DATE: February 16, 2021
PROJECT: The Woods of Wellington
Lot 6

RE: Woods of Wellington Lot 6
Percolation Certification Plan and OSDS Design Plan

REVISED PERCOLATION CERTIFICATION PLAN
LOT 6
THE WOODS OF WELLINGTON
PLAT NO. 15288
3300 HUNTSWORTH
ELECTION DISTRICT No. 4
HOWARD COUNTY, MARYLAND
SCALE: 1" = 30' NOVEMBER, 2020

WOODS OF WELLINGTON
LOT 6

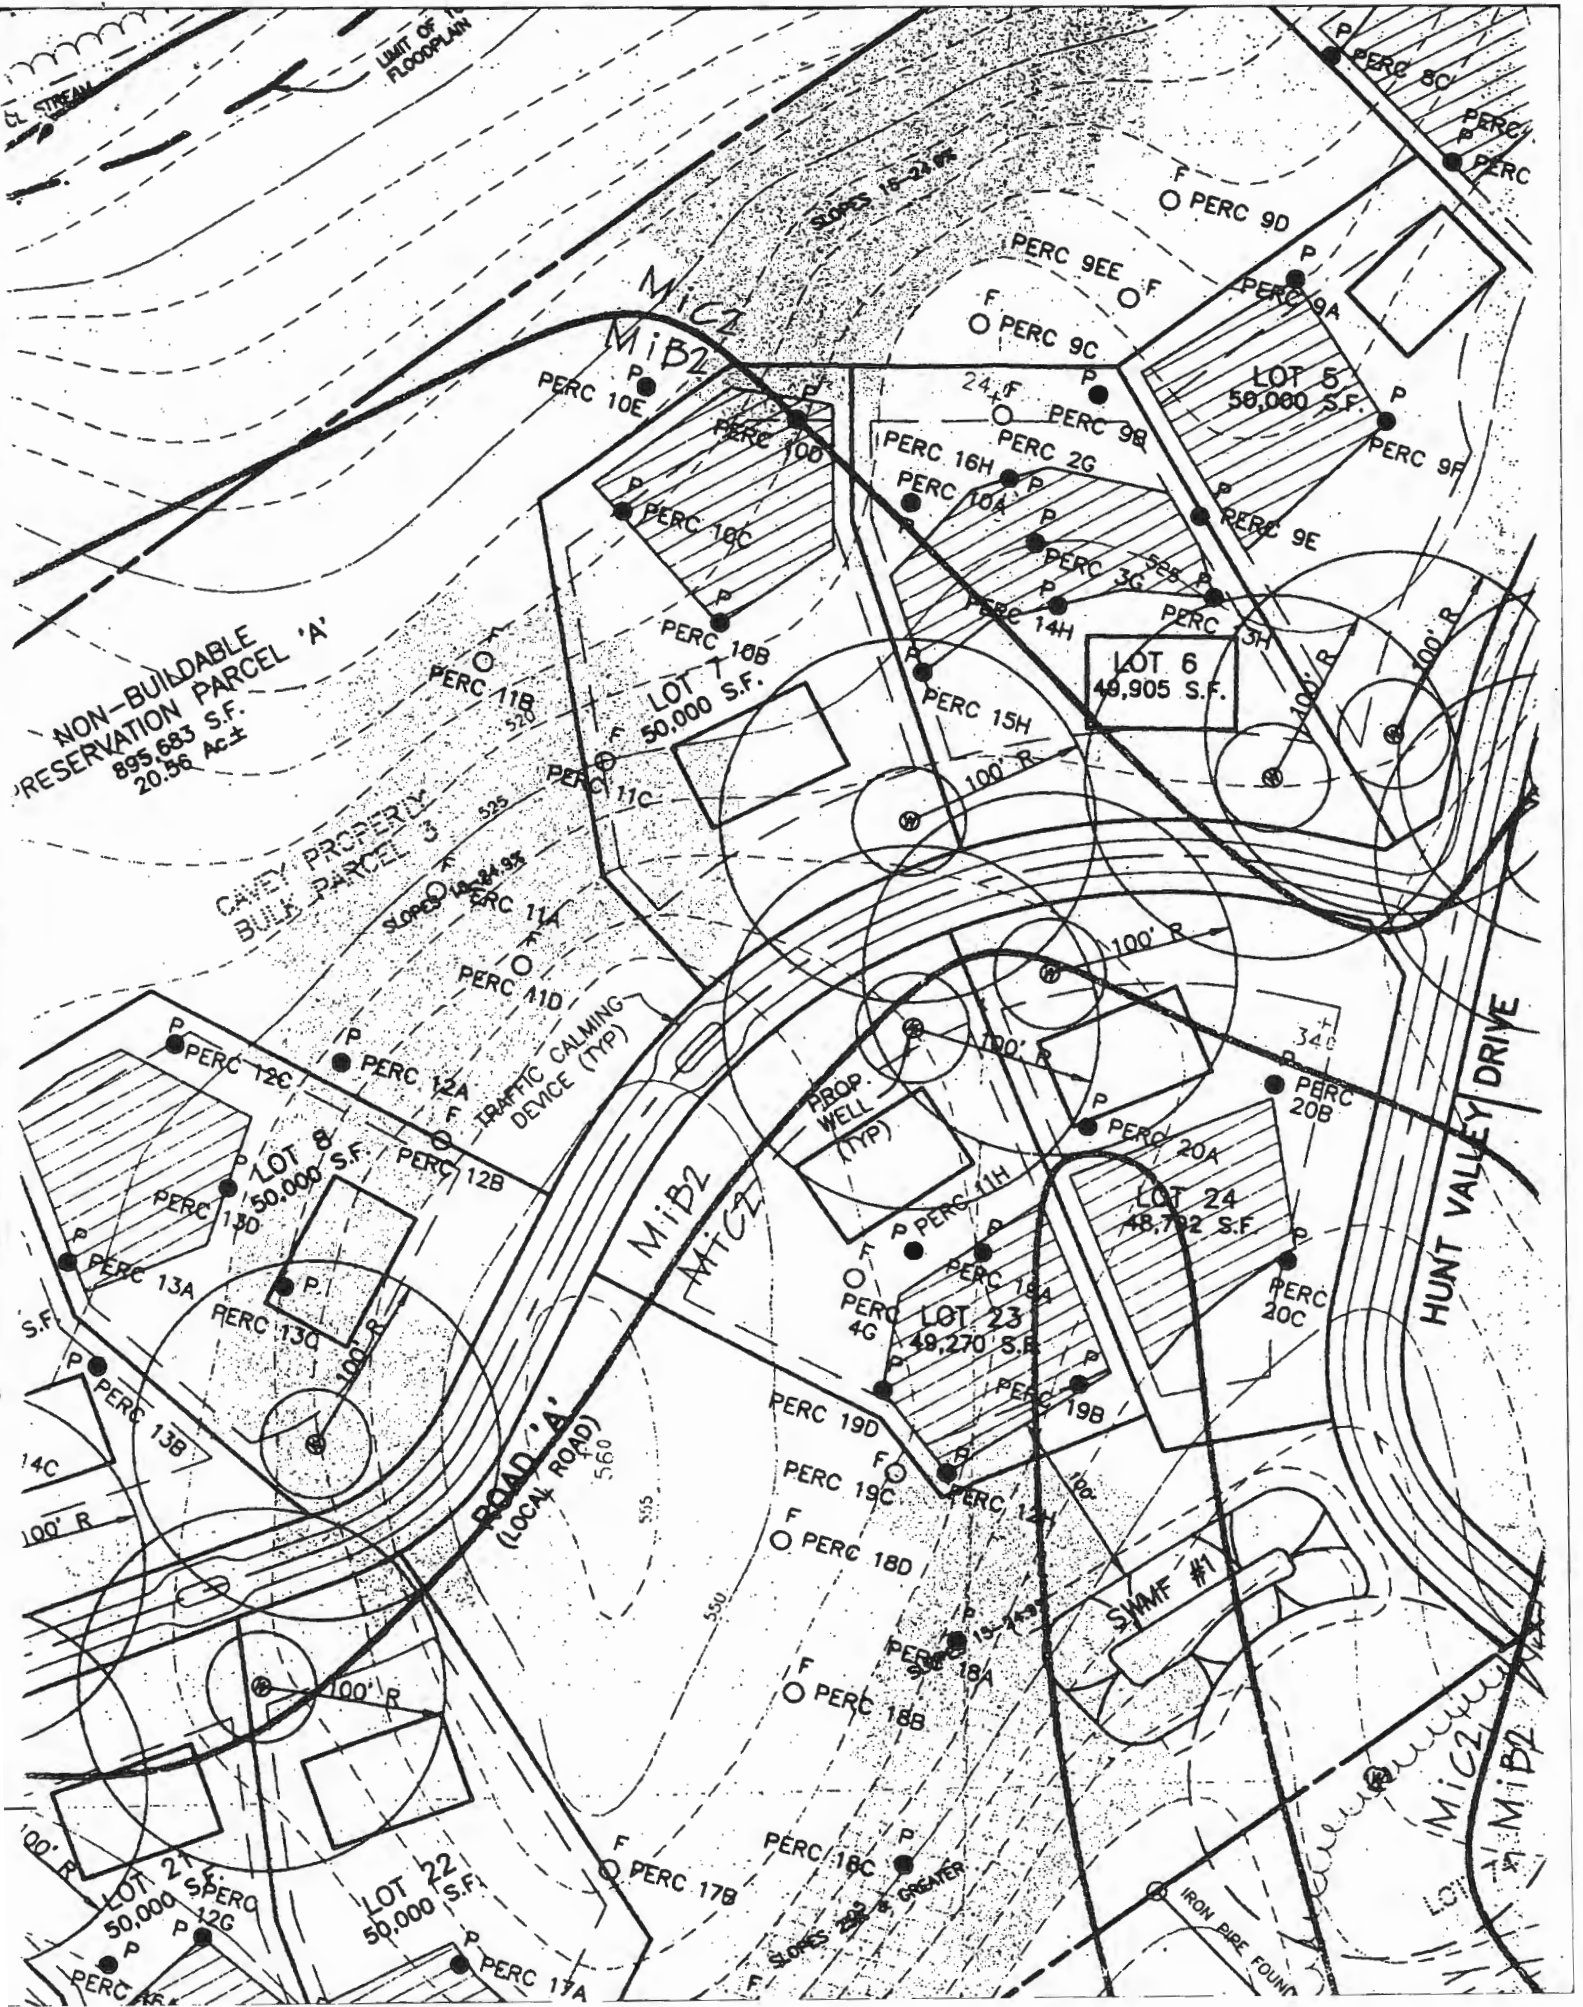
(HR)
8/5/02 REVIEW:
POTENTIALLY OK, BUT
NEED PERCS TO FIND
EDGE OF ROCK @
Attachments
REAR OF EX. SDA;
NEED PLAN, FEE, APPL.

8/6/02 MTC. w/ Nancy Boone
(HR) Best to perc for
red line as shown,
by following Rx from
failed test hole 26

LOT 6
49,905 s.f.

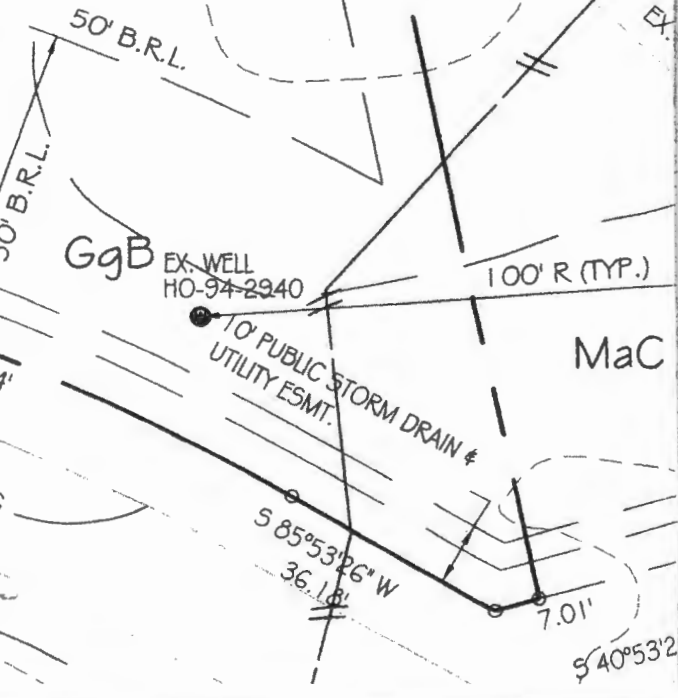
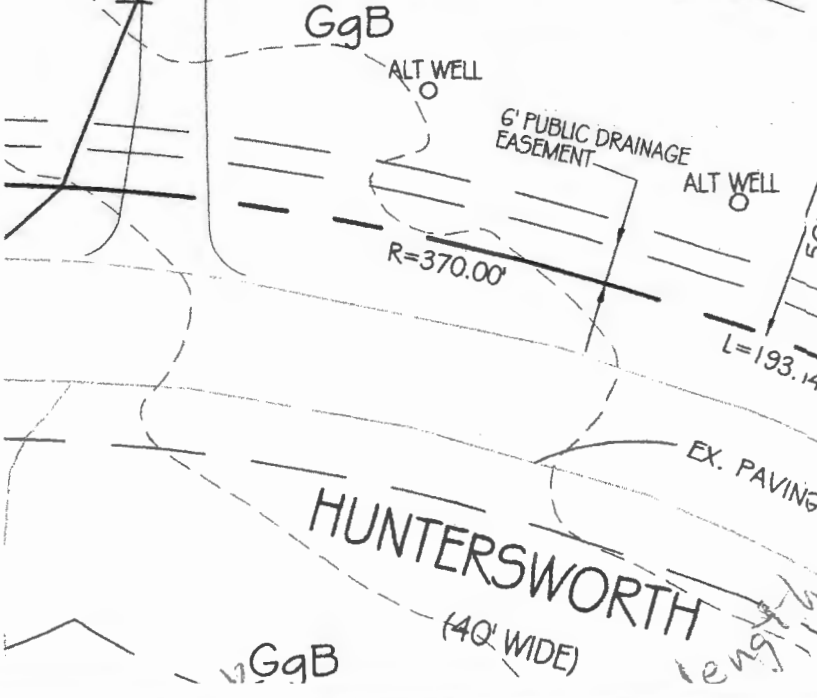
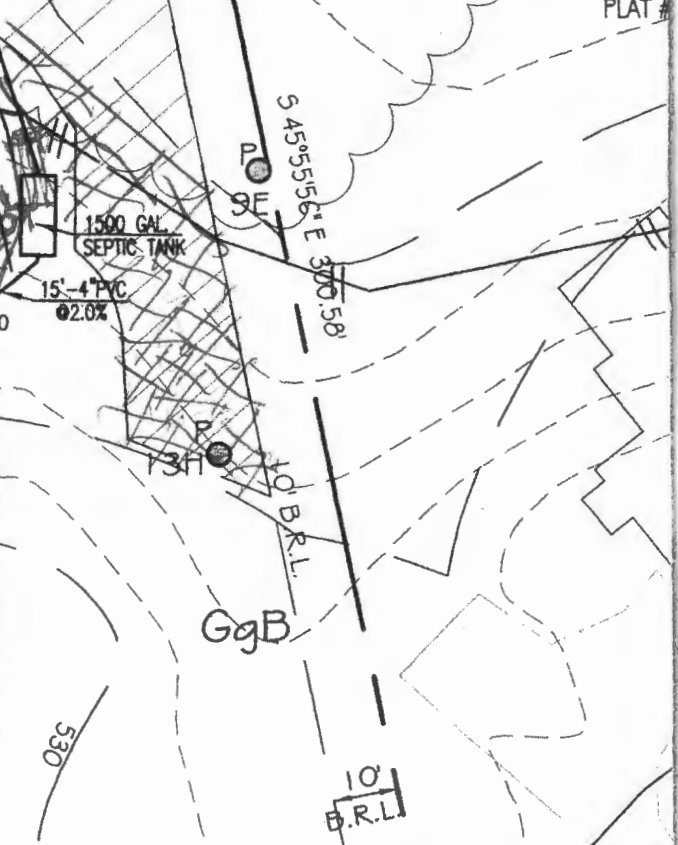
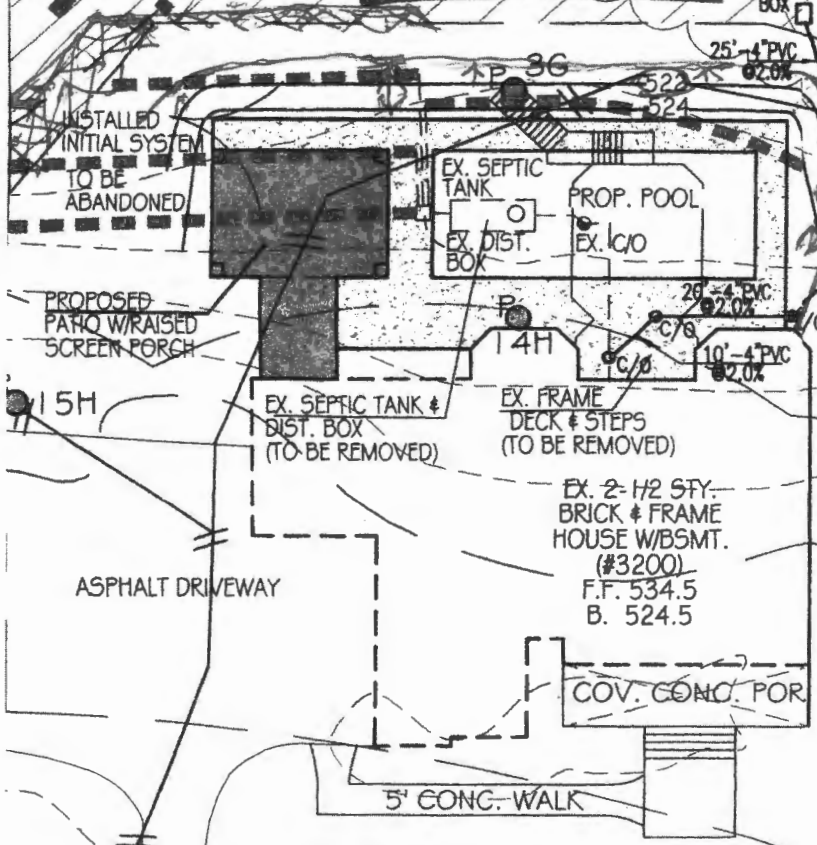
1. The septic tank is proposed within 20-ft setback to the existing house foundation.
2. The slope between the 522 and 524 contours is too narrow, creating a slope greater than 25% within 25 feet of the SDA.
3. Portions of the proposed SDA do not allow for the installation of distribution trenches at least 40 feet in length. These areas are not approvable for the SDA. I Have used 'x's to indicate areas not approvable in the proposed SDA. Area west of failed location '2G' may be appropriate for inclusion in the modified SDA, though that area will have to be tested for potential inclusion in the SDA.

3. *Portions of the proposed SDA do not allow for the installation of distribution trenches at least 40 feet in length. These areas are not approvable for the SDA. I have used 'x's to indicate areas not approvable in the proposed SDA. Area west of failed location '2G' may be appropriate for inclusion in the modified SDA, though that area will have to be tested for potential inclusion in the SDA.*

Response 3: The proposed SDA has been revised per the attached markup. Please note three trench systems (new initial and 2 replacements) are within the area of approved percolation test locations. Therefore, we do not believe additional percolation tests are required.

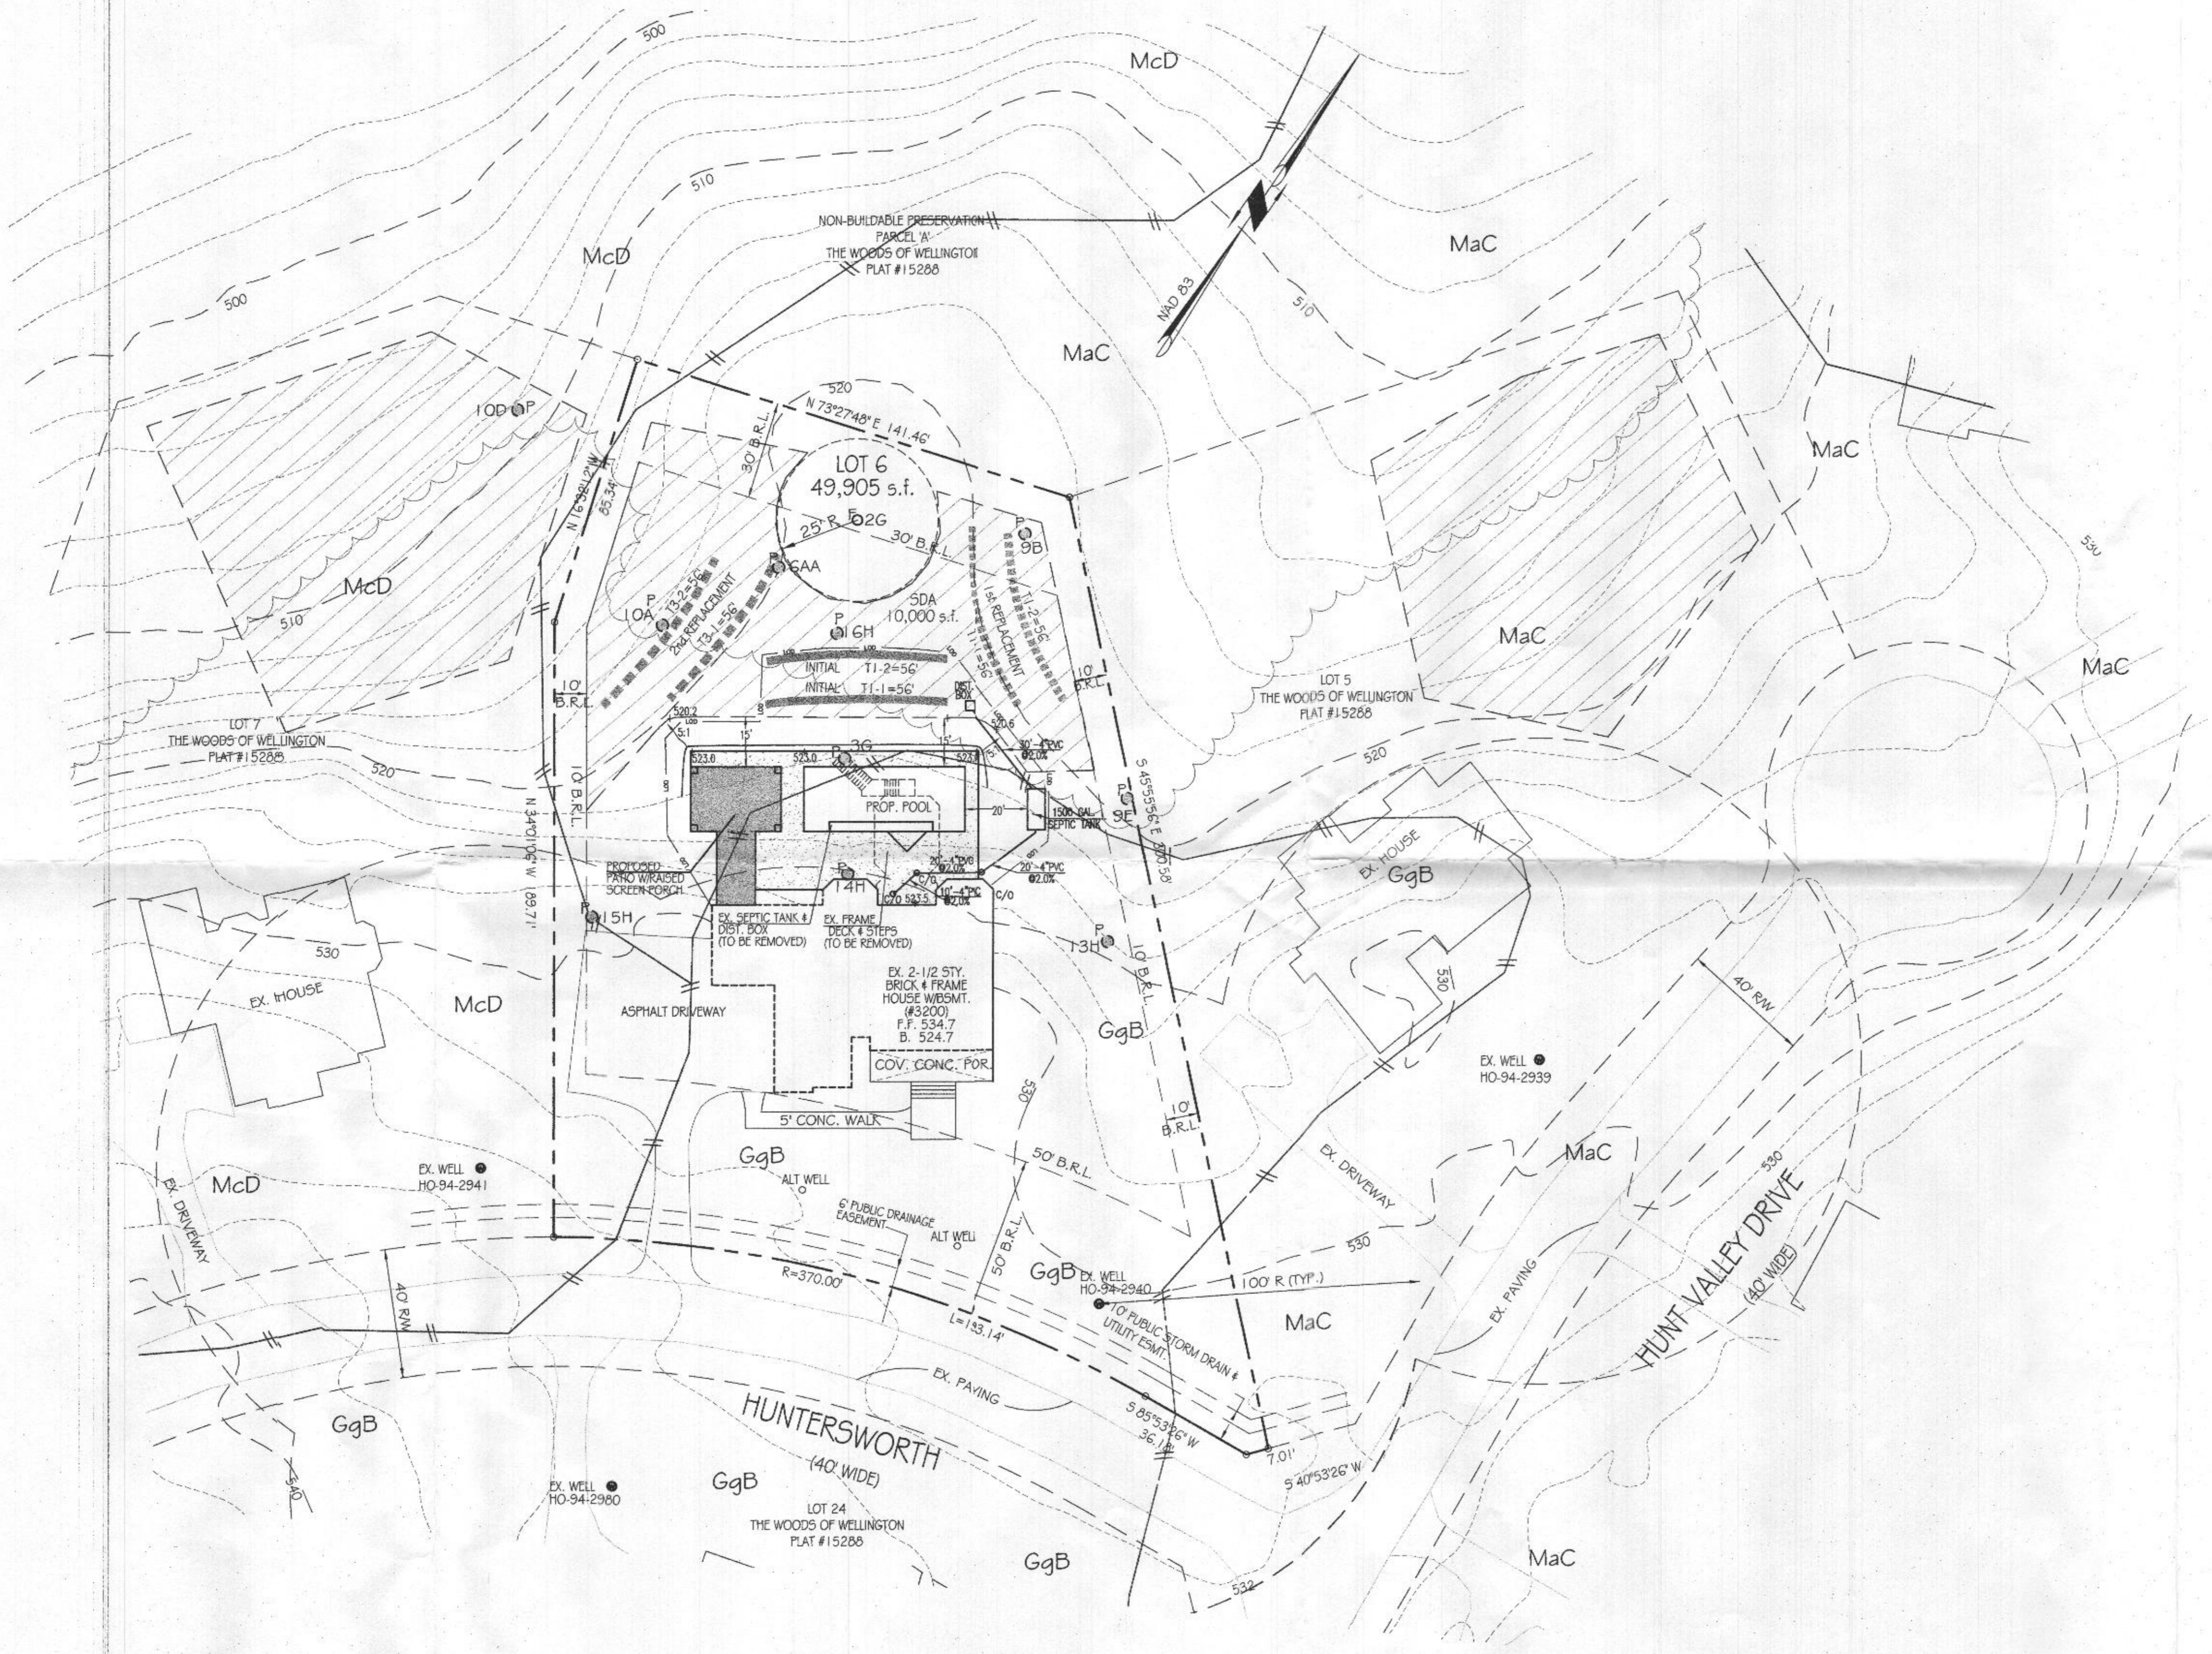
The Percolation Certification Plan revision (and associated OSDS Design Plan) for Woods of Wellington Lot 6 will not be approved at this time. Percolation tests are required to prove the area proposed to be added to the sewage disposal area near the back-left corner of the property. Two tests should be staked for testing: one about 25 feet west of failed location '2G', and the other about 15 feet from the back-left property corner.

1. The septic tank is proposed within 20-ft setback to the existing house foundation.
2. The slope between the 522 and 524 contours is too narrow, creating a slope greater than 25% within 25 feet of the SDA.
3. Portions of the proposed SDA do not allow for the installation of distribution trenches at least 40 feet in length. These areas are not approvable for the SDA. I Have used 'x's to indicate areas not approvable in the proposed SDA. Area west of failed location '2G' may be appropriate for inclusion in the modified SDA, though that area will have to be tested for potential inclusion in the SDA.

Response 1: The septic tank is now more than 20 ft from the existing house foundation.

Response 2: The slopes have been revised so that the slope within 25 ft of the SDA is less than 25%.

Response 3: The proposed SDA has been revised per the attached markup. Please note three trench systems (new initial and 2 replacements) are within the area of approved percolation test locations. Therefore, we do not believe additional percolation tests are required.
